Section 4.55(2) Modification Application to DA35/2024

1 Gatacre and 1-5 Allison Avenues, Lane
Cove

APRIL 2025

Figure 15: Proposed Level 3 Design
Source: PBD Architects

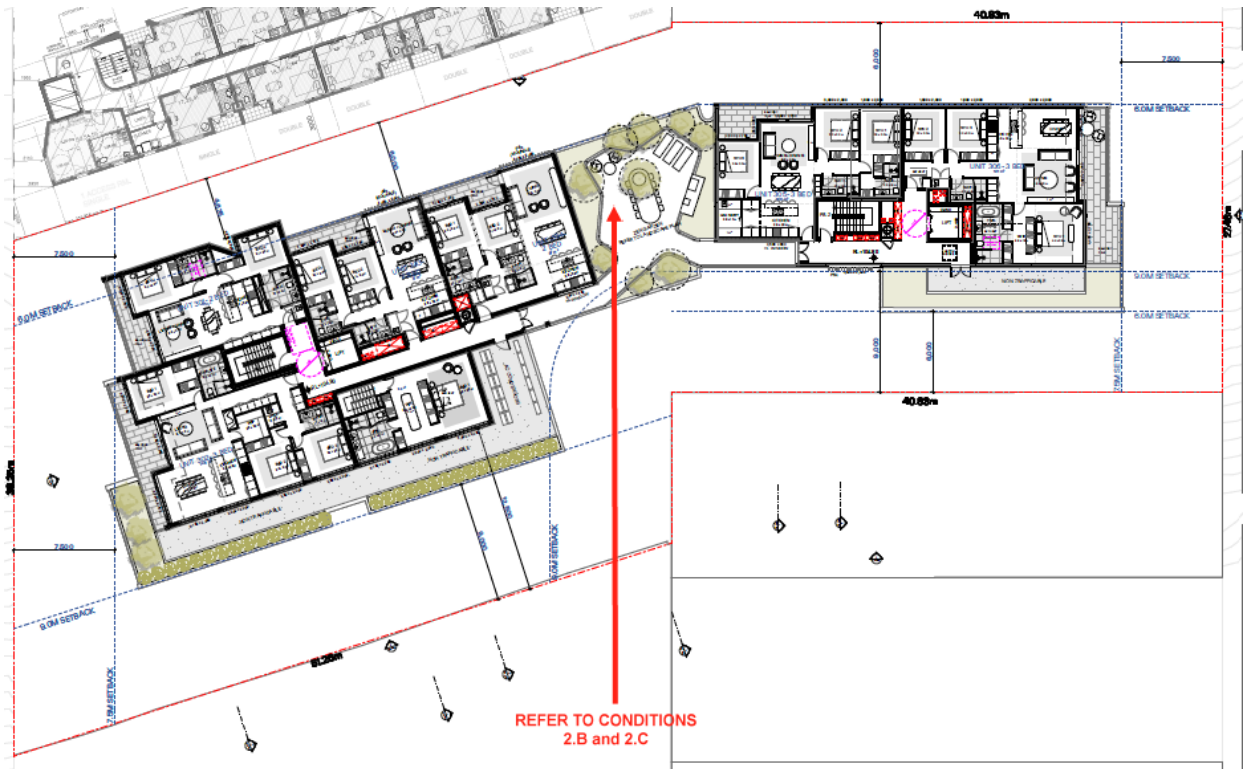
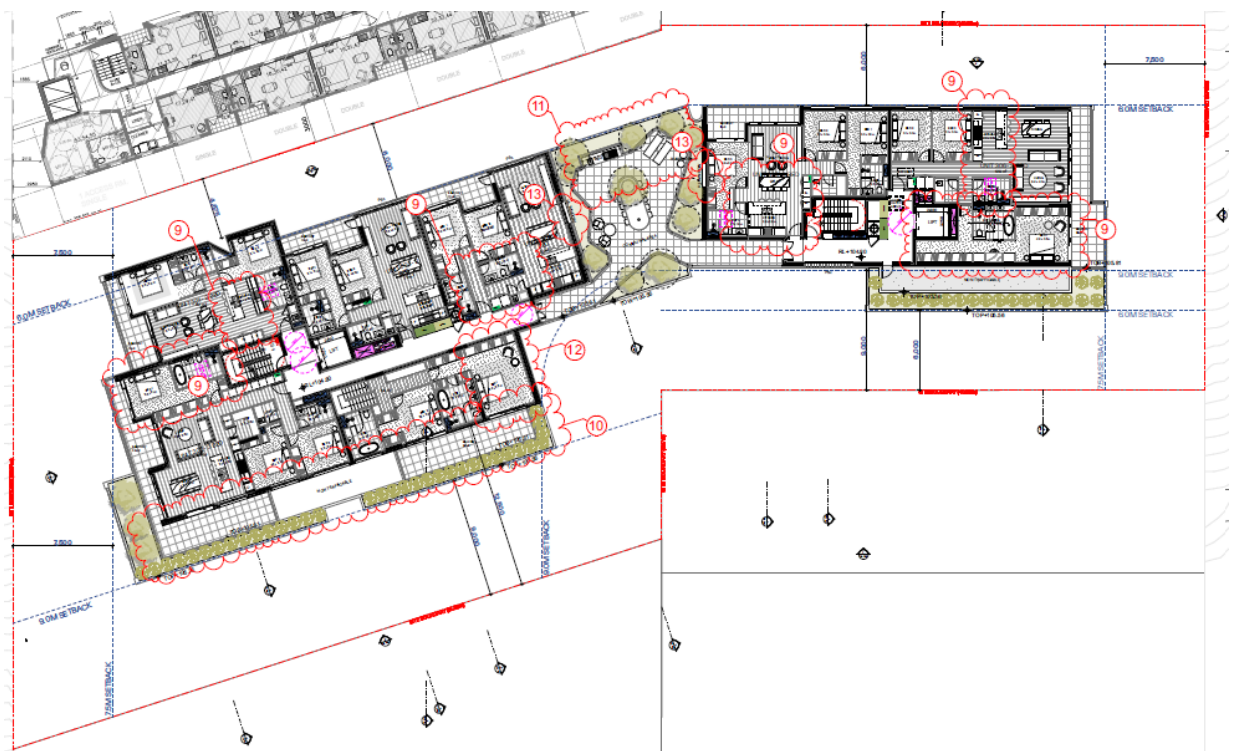
- Change 9 - Standardized apartment layouts: Interior layouts have been amended for uniformity across all apartments;
- Change 10 - Terrace modification: A previously non trafficable terrace has been converted into a private open space for units 205, 302, 401, and 402;
- Change 11 - Amended rooftop area design. The BBQ area has been repositioned for better accessibility and functionality and a general utility sink and rubbish bin added;
- Change 12 - Unit 205 has been expanded; and
- Change 13 - Highlight windows have been added to the wall between the communal open space and Units 304 and 305 to improve solar amenity.

A comparison between the approved and proposed design of the Level 3 is demonstrated in Figure 14 and Figure 15.

Figure 17: Proposed Level 4 Design
Source: PBD Architects

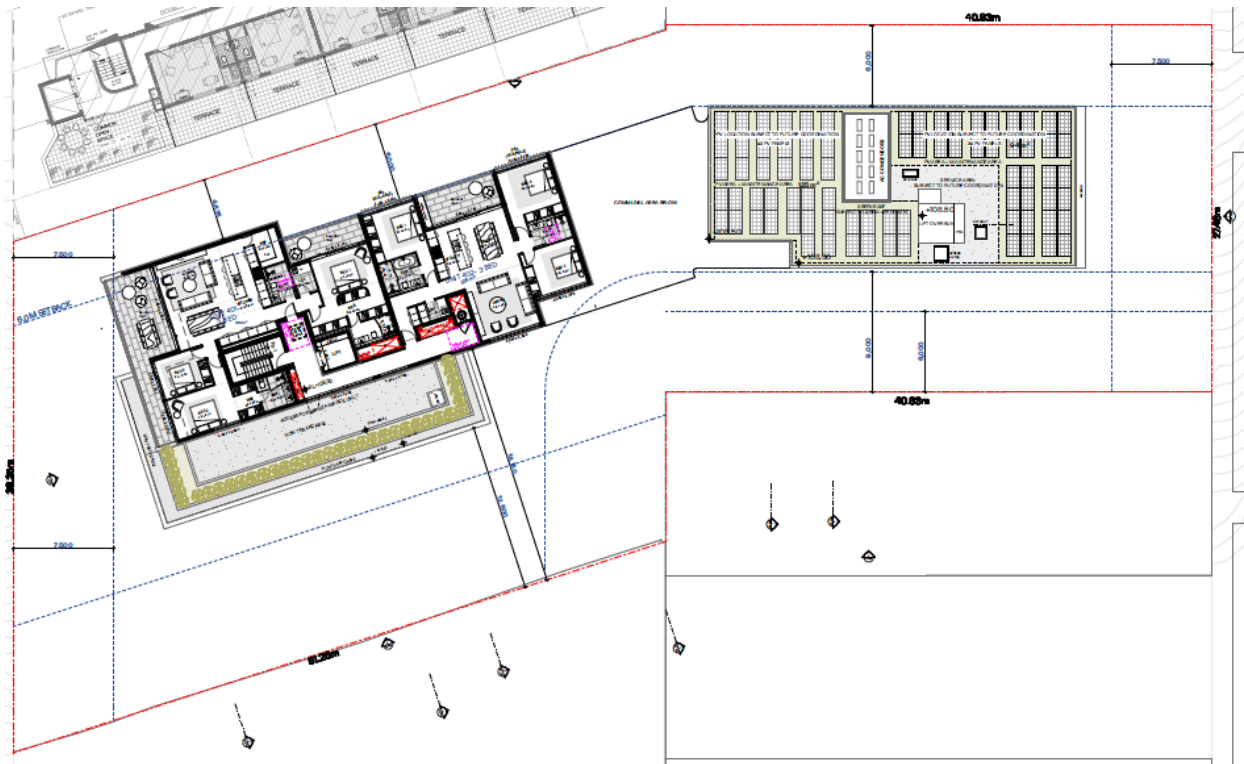
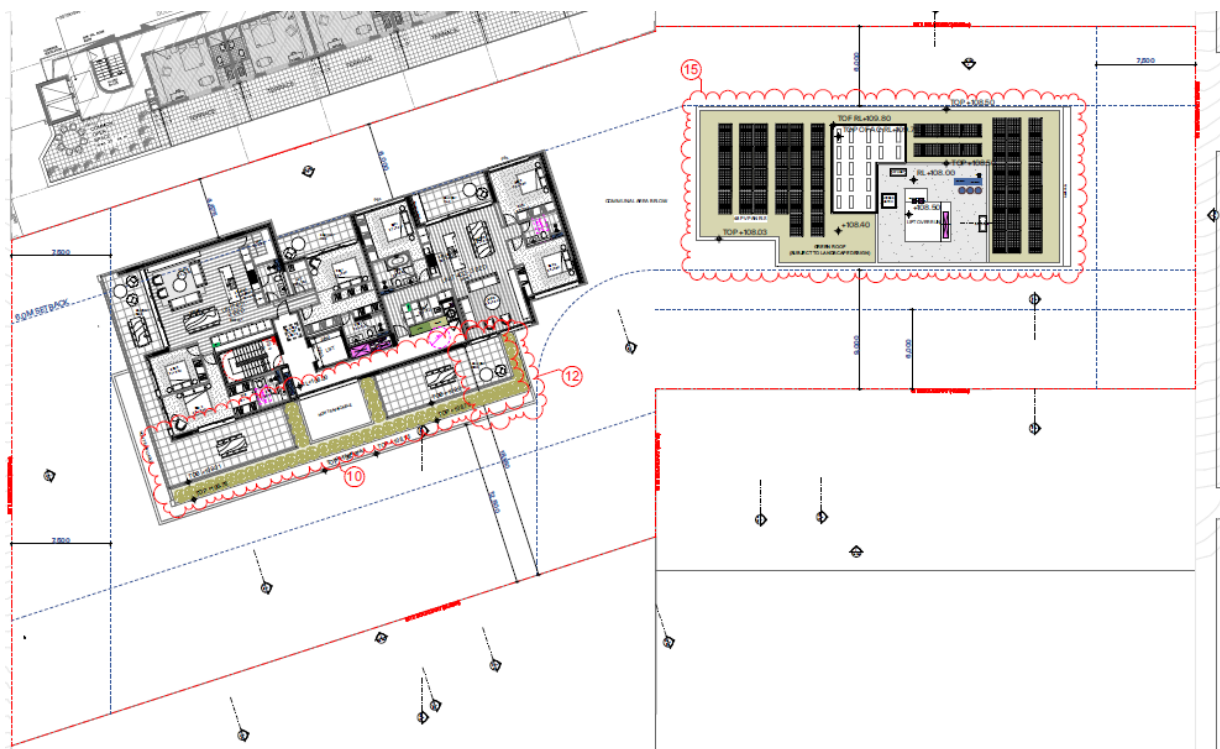
- Change 10 - Terrace modification: A previously non trafficable terrace has been converted into a private open space for units 205, 302, 401, and 402;
- Change 12 - Unit 205 has been expanded; and
- Change 15 - The number of PV panels has been reduced from 175 to 130 to accommodate the relocated chiller plant, decreasing rooftop solar capacity from 78kw to 57kw.

A comparison between the approved and proposed design of the Level 4 is demonstrated in Figure 16 and Figure 17.

Figure 19: Proposed Roof Design
Source: PBD Architects

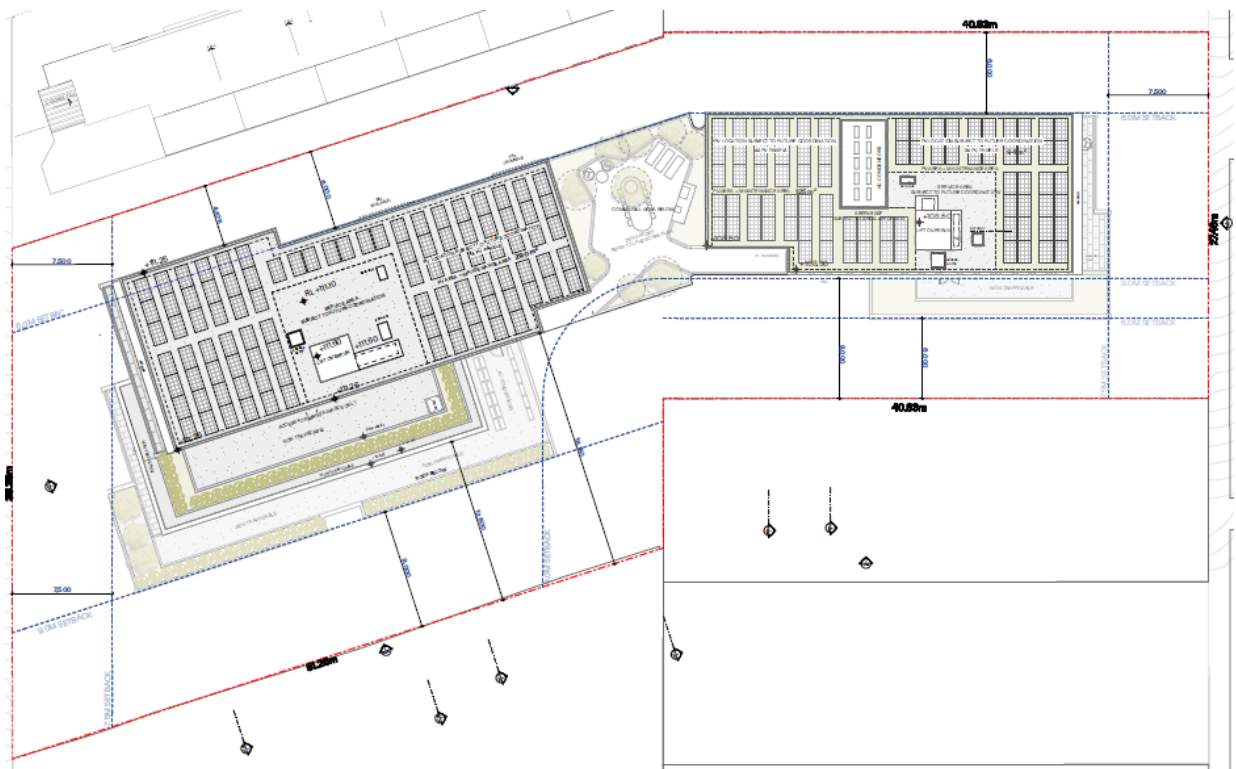
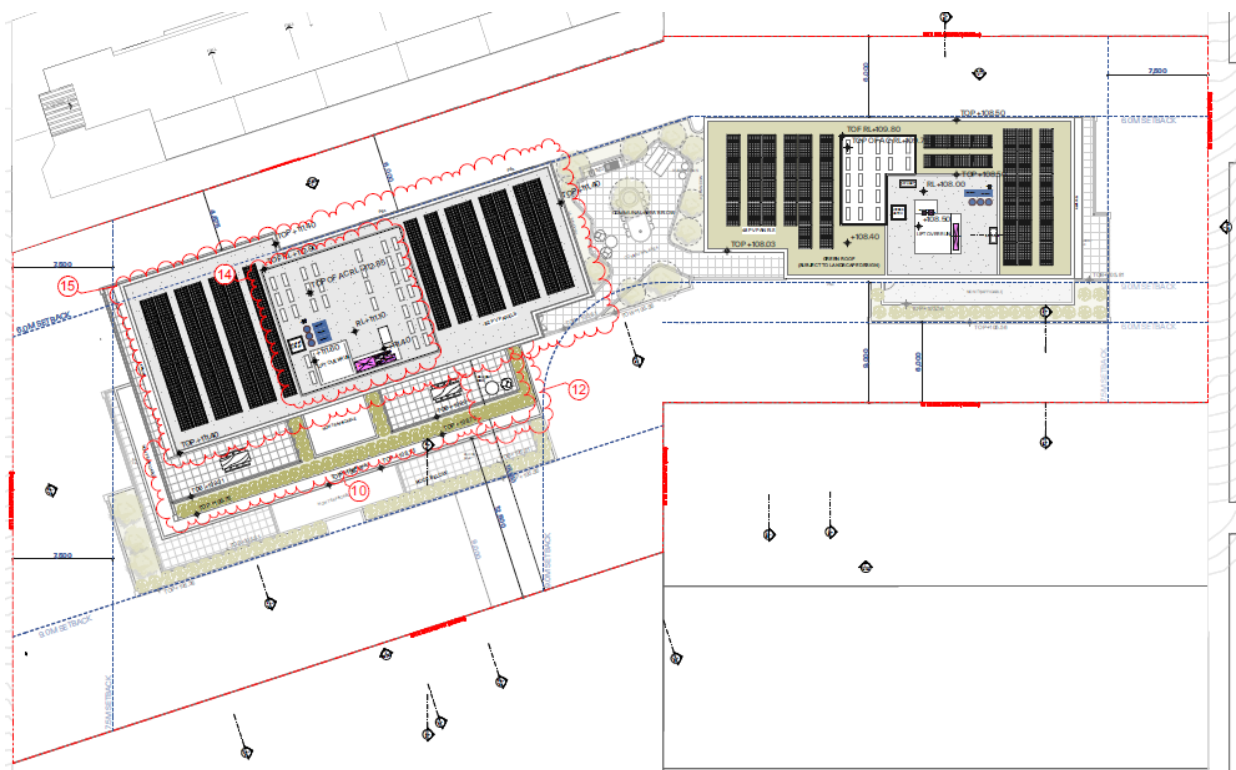
- Change 10 - Terrace modification: A previously non trafficable terrace has been converted into a private open space for units 205, 302, 401, and 402;
- Change 12 - Unit 205 has been expanded;
- Change 14 - Air conditioning units have been moved to the roof level; and
- Change 15 - The number of PV panels has been reduced from 175 to 130 to accommodate the relocated chiller plant, decreasing rooftop solar capacity from 78kw to 57kw.

A comparison between the approved and proposed design of the roof is demonstrated in Figure 18 and Figure 19.

Figure 21: Proposed Northern Elevation Design

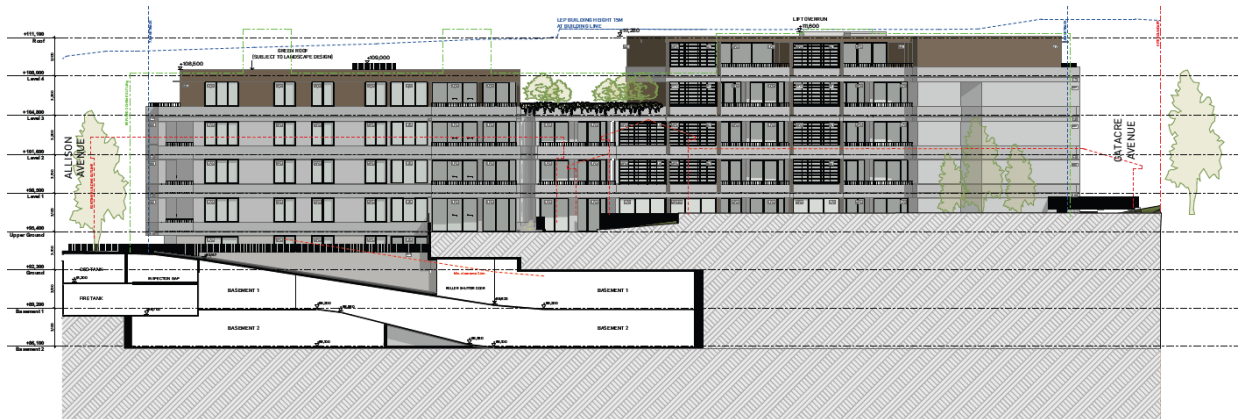
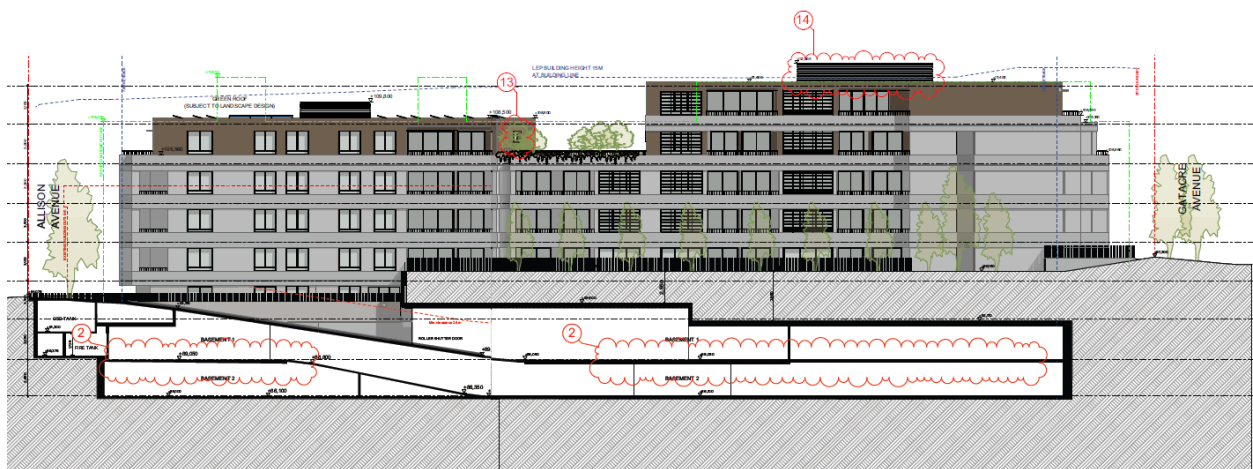
- Change 2 - Basement 1 slab RL lowered by 150mm to increase ceiling clearance;
- Change 13 - Highlight windows have been added to the wall between the communal open space and Units 304 and 305 to improve solar amenity; and
- Change 14 - Air conditioning units have been moved to the roof level.

A comparison between the approved and proposed design of the northern elevation is demonstrated below in Figure 20 and Figure 21.

Figure 22: Approved Southern Elevation Design
Source: PBD Architects

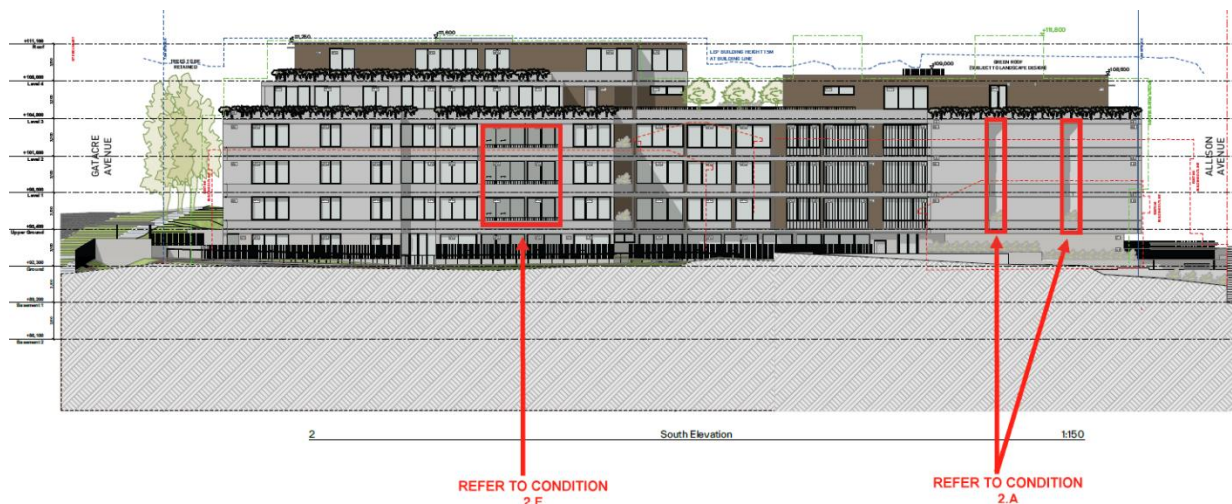
- Change 10 - Terrace modification: A previously non trafficable terrace has been converted into a private open space for units 205, 302, 401, and 402;
- Change 12 - Unit 205 has been expanded; and
- Change 14 - Air conditioning units have been moved to the roof level.

A comparison between the approved and proposed design of the southern elevation is demonstrated below in Figure 22 and Figure 23.

Figure 26: Sightline Diagram for Southern Oblique Windows
Source: PBD Architects

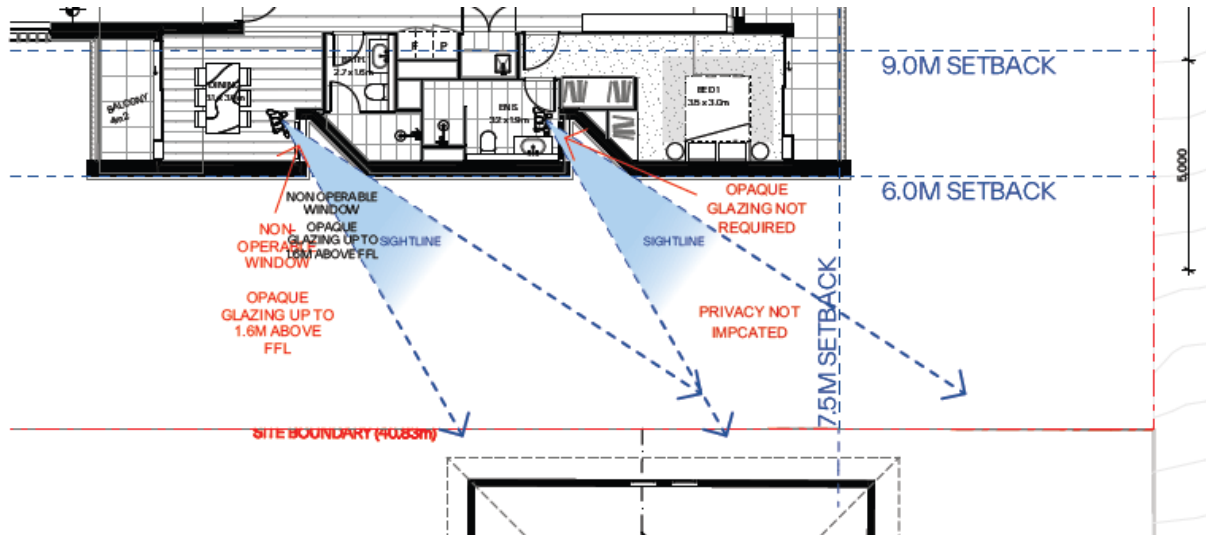
A. All oblique, diagonal facing windows **from habitable rooms** on the southern external walls must be non-operable and be an obscure finish up to 1.6m above finished floor level.

Patch Planning Comment: The proponent is seeking to amend sub condition 2A, as it has been demonstrated that only the oblique, diagonal facing windows from habitable rooms on the southern external walls require privacy measures, as per Figure 26. The oblique windows from the ensuite bathrooms in their current form (operable with clear glazing) will not impact 7 Allison Avenues privacy.

Figure 27: Sightline Diagram for Southern Balconies
Source: PBD Architects

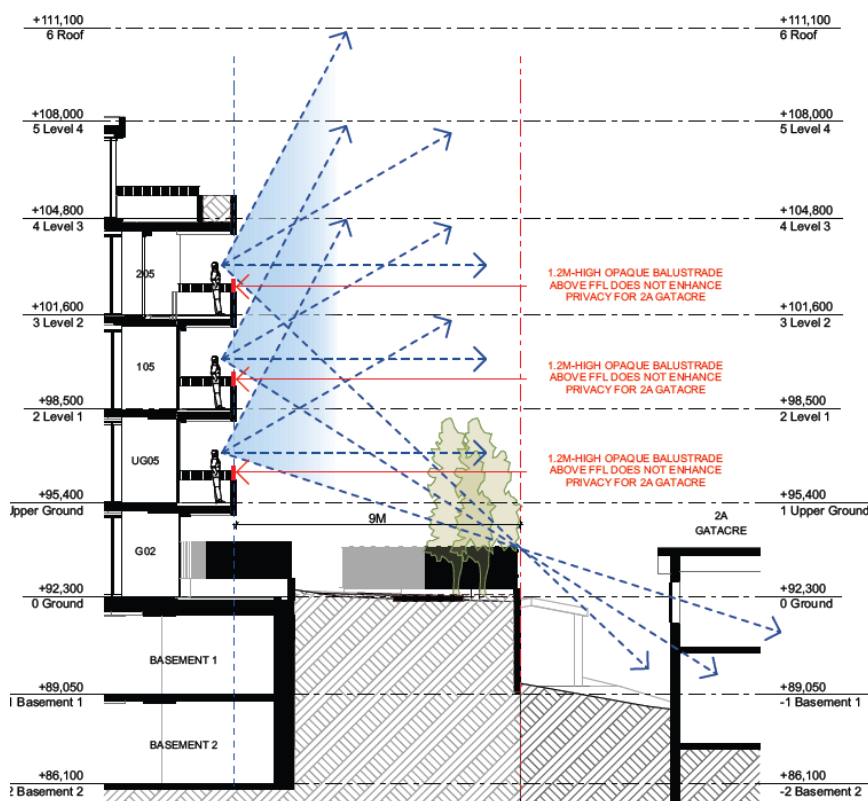
~~F. The balustrades of the south facing balconies of Units UG.05, 105 and 2.05 are to be constructed with solid obscure finishes up to 1.2m above FFL.~~

Patch Planning Comment: The proponent is seeking to delete sub condition 2F, as it has been demonstrated that altering the balustrades of the south facing balconies of Units UG.05, 105 and 2.05 to be constructed with solid obscure finishes up to 1.2m above FFL, will not enhance privacy for 2A Gatacre and would undermine the design intent, as per Figure 27.

Figure 29. Proposed Exceedance to Maximum Building Height Facing Gatacre Avenue
Source: PBD Architects

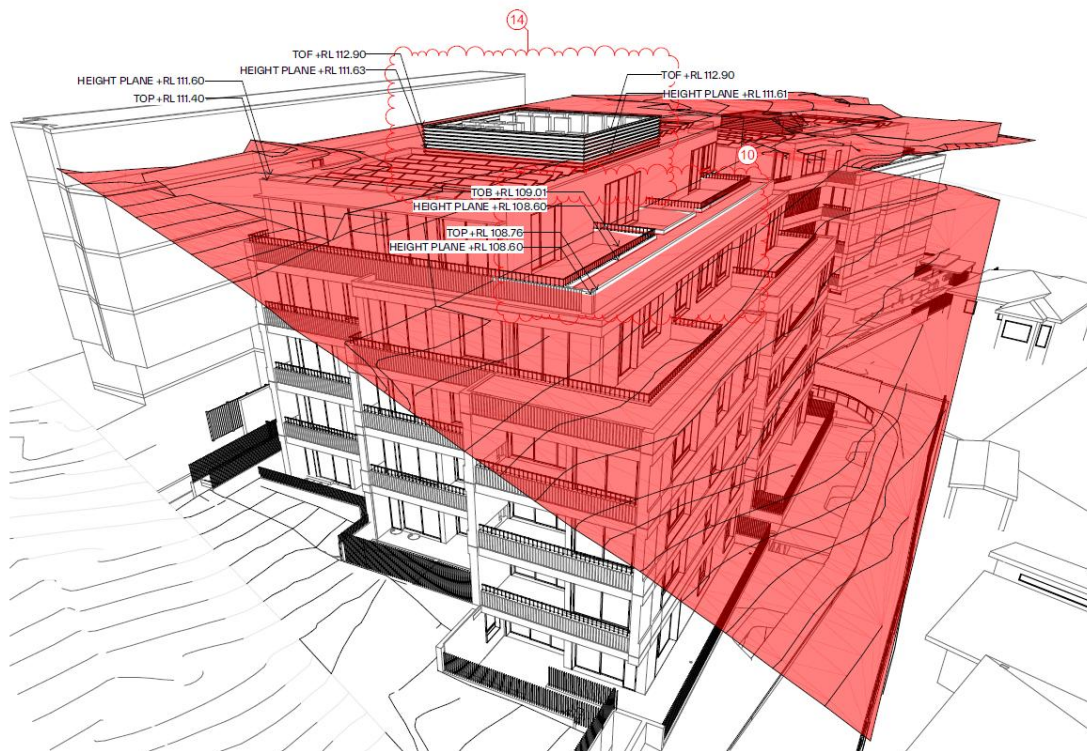
As a result of relocating the air conditioning plant from Level 3 to the roof of Building A the maximum building height of the development has been marginally increased, resulting in a maximum **RL112.90**, a varying increase of **1.27m to 1.29m** and a revised maximum building height of to **16.290m** measured at top of service plant fence. This represents a 9% exceedance.
